Public Works (1914) Department.

G.O. No. 310 I

Minor works, P.W.D., Madura Dt.

approving the list & map of — as finally revised and submitted by the Chief Engineer for Irrigation

SKETCH MAP
SHOWING
PONNAMANGALAM CHINNA KY. AND PERIYA KY.
SCALE 1" = 1 MILE
(Nos 146 + 145 IN THE REVISED LIST)
N
PONNAMANGALAM
PERIAKANMOY
SORIKKAMBATTI
CHINNAKANMOY
KUNNAMBATTI
VAILAMPATTI M. I
KARADIKULAM
PONNAMANGALAM
ORAPPANUR
SENKULAM
TIRUMANGALAM
EXECUTIVE ENGINEER
MADURA DIVISION

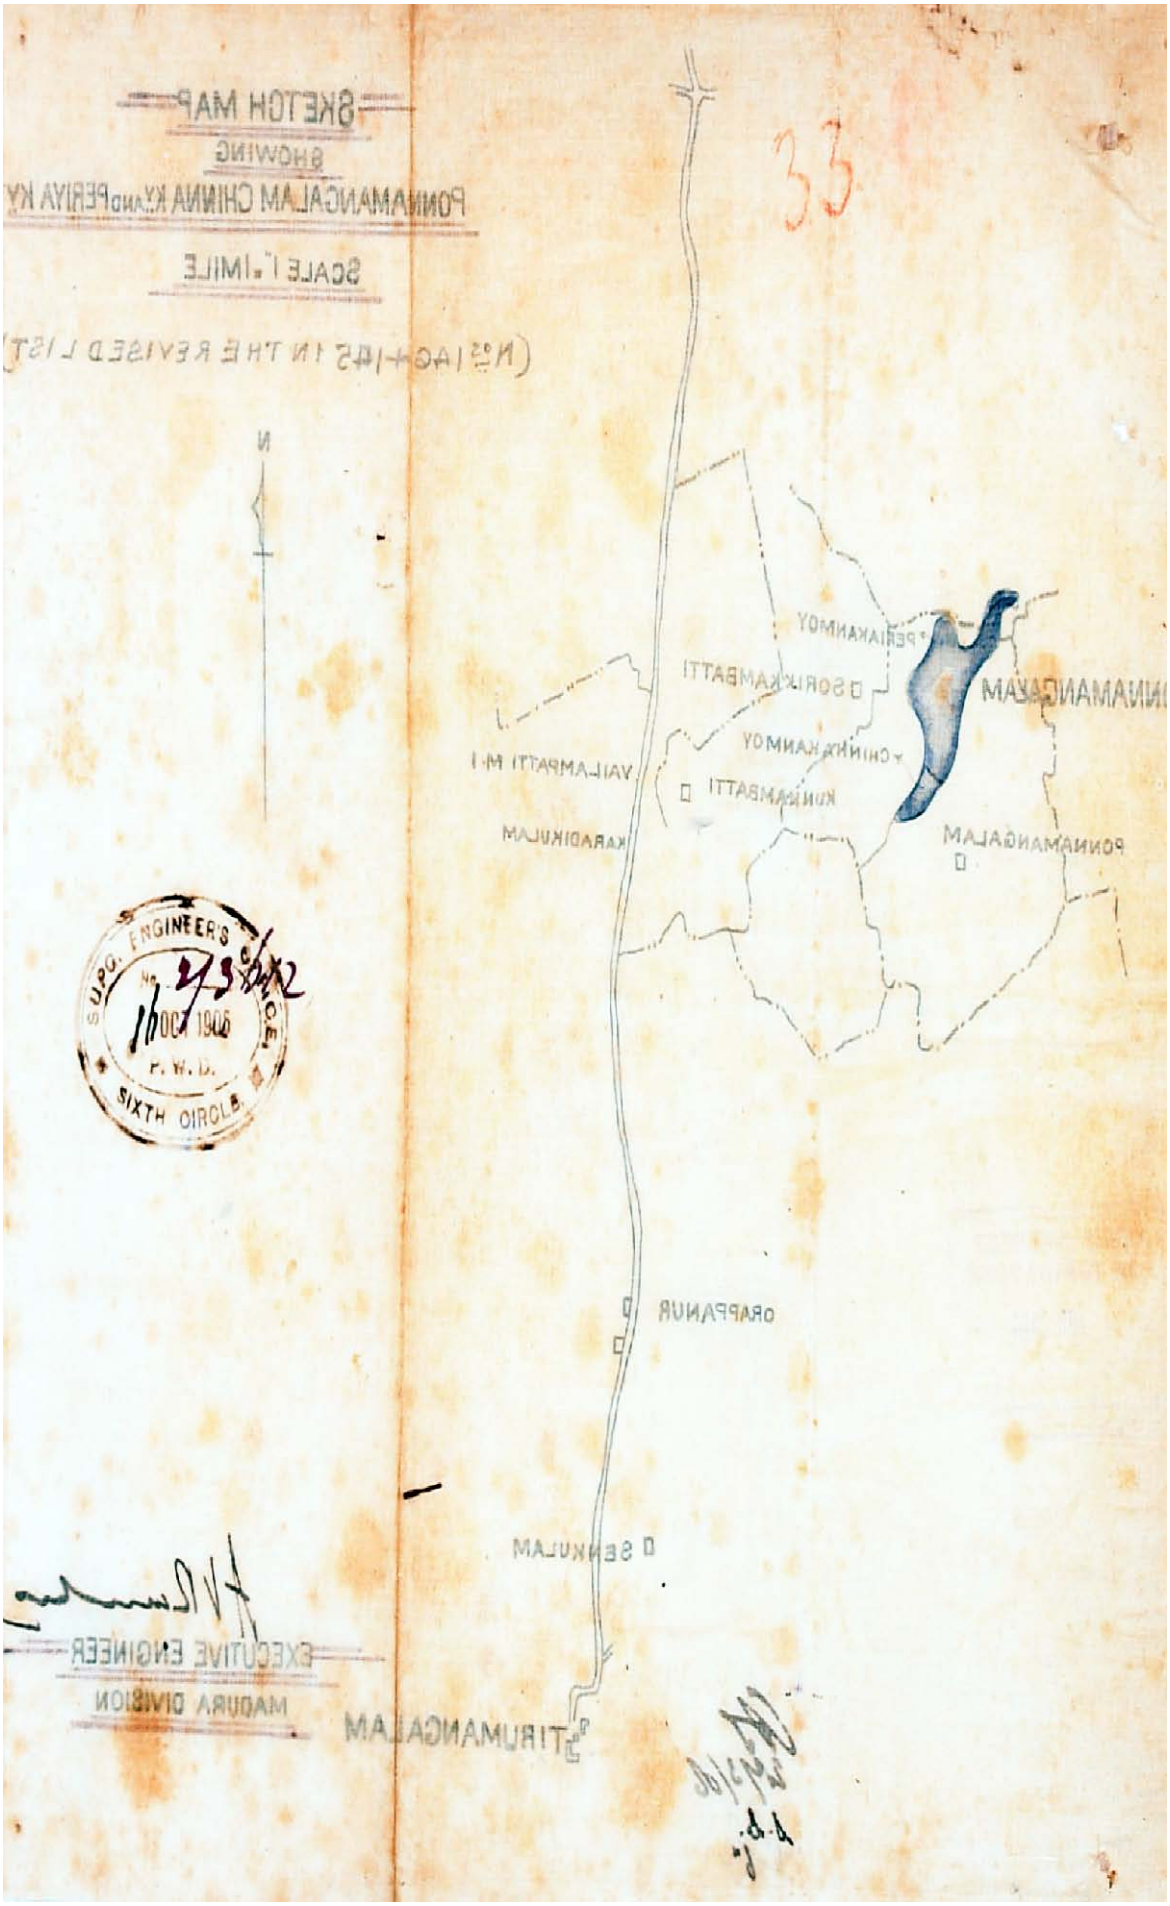
With regard to the proposal made in his letter No.189 C.E., dated 9th March 1905, of the Supg. Engineer regarding the transfer to the P.W.D. of the 3 marginally noted works, it is requested that as the positions of the first two tanks are not traceable, a sketch map on a scale of 1" = 1 mile showing their positions should be submitted and the tanks included in the revised list returned herewith.

With regard to the penultimate para of your memorandum under reference, on the question of transferring from the Revenue Department to the P.W.D. the 3 tanks referred to therein, have been now included in the revised list and also shewn on the map. Apart from this, sketch maps on larger scale indicating their positions are also forwarded as desired by you.

FRACING
SHOWING
MANTHAIKULAM ANICUT M.No: 19/14
Imperial. No. 38.

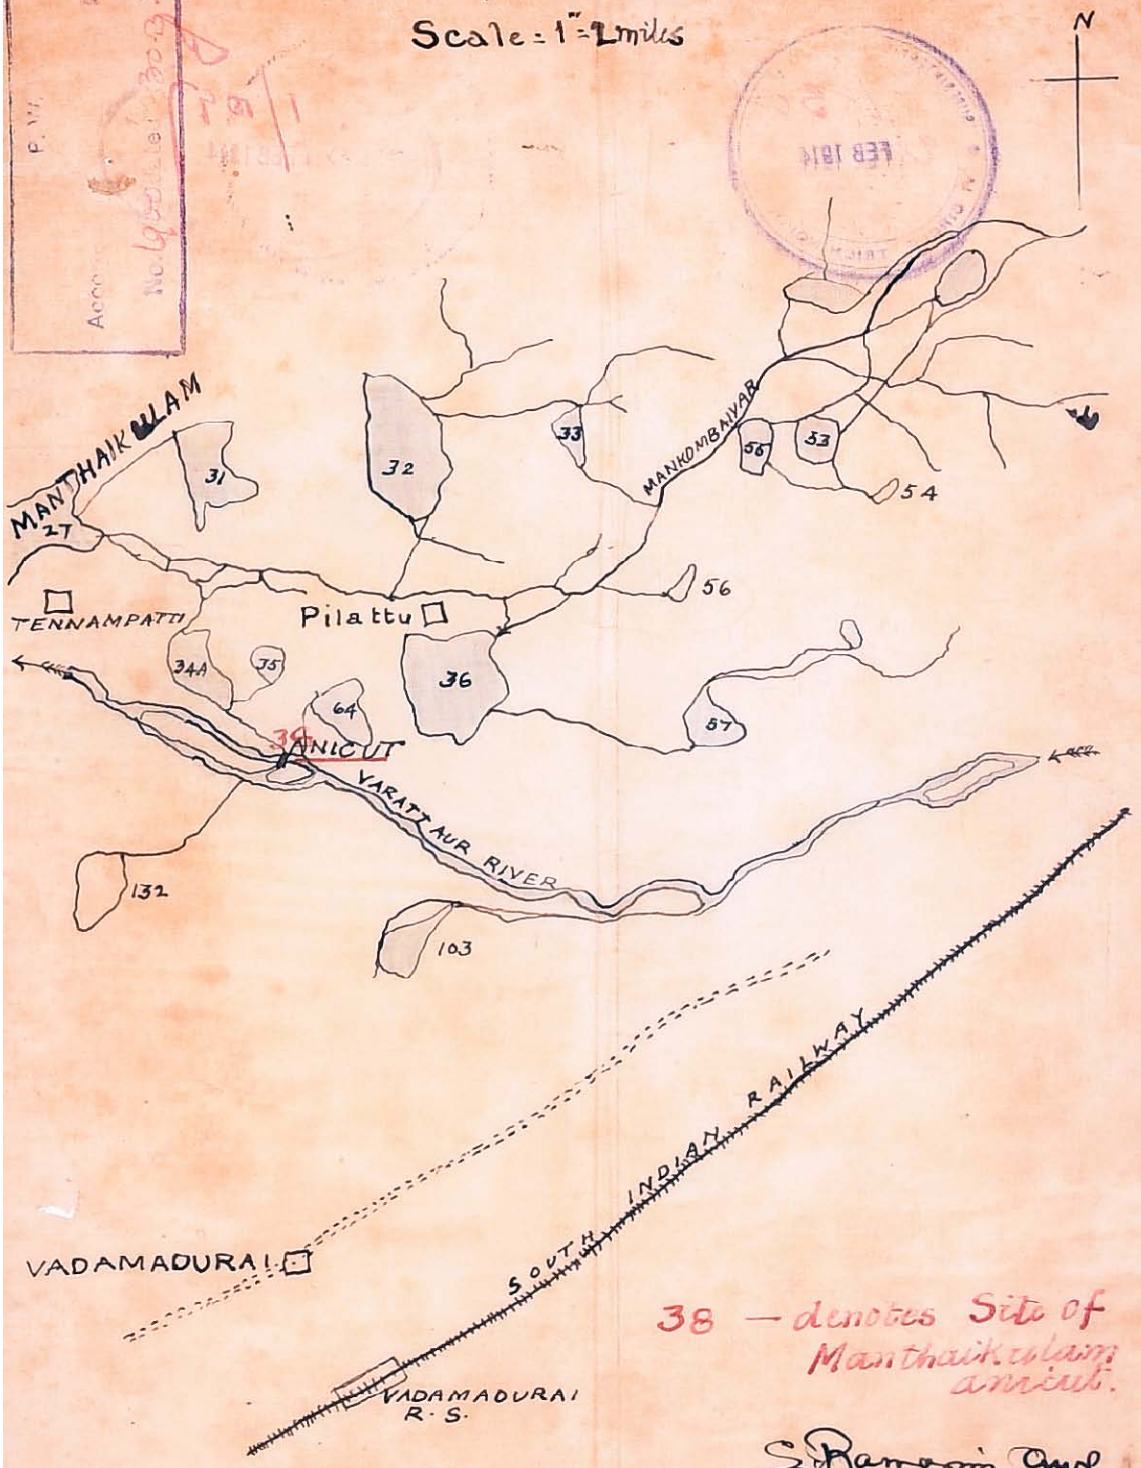
2. *Manthaikulam anicut No. 36 in the revised list.*—The position of this work said to be about three miles north of Vadamadurai station is not traceable on the map of Dindigul minor basin, Volume I, but there is one of the same name on the Varattaur at about six miles west of Vadamadurai station, longitude 78–4–0, latitude 10–28–0. There is also another anicut shown at the head of Uttalamkulam supply channel—*vide* No. 37 on page 45 of the descriptive memoir of Dindigul minor basin. It is therefore requested that a sketch map showing clearly the position of the Manthaikulam anicut may be submitted.

P a r a II.- Manthaikulam Anicut.-No.36 in the revised list.- The anicut is situated $1\frac{3}{4}$ miles north of Vadamadura - and $\frac{3}{4}$ of a mile south east of No.34 Thamaraipatti Village. - This anicut is also known as Pudukulam Anicut described on page 42 of the T.R.S. Descriptive Memoirs for Dindigul Minor Basin. A sketch map is herewith enclosed.

(2) It is reported that the Manthaikulam anicut in Dindigul taluk (No. 36 in the list) is the anicut across the Varattar 1¾ mile north of Vadamadurai Station. As this anicut as described on pages 42 and 43 of Dindigul minor basin Descriptive Memoirs has an ayacut of only 13 acres, it appears probable that the work intended to be included in the list and map of Minor works, Public Works Department, is the Manthaikulam tank described on page 40 of the Descriptive Memoirs of Dindigul minor basin as having an ayacut of 183 acres and not the "Manthaikulam anicut" which has an ayacut of only 13 acres. The Superintending Engineer will be asked to report on this point. Pending his report, the anicut may be eliminated from the list and map.
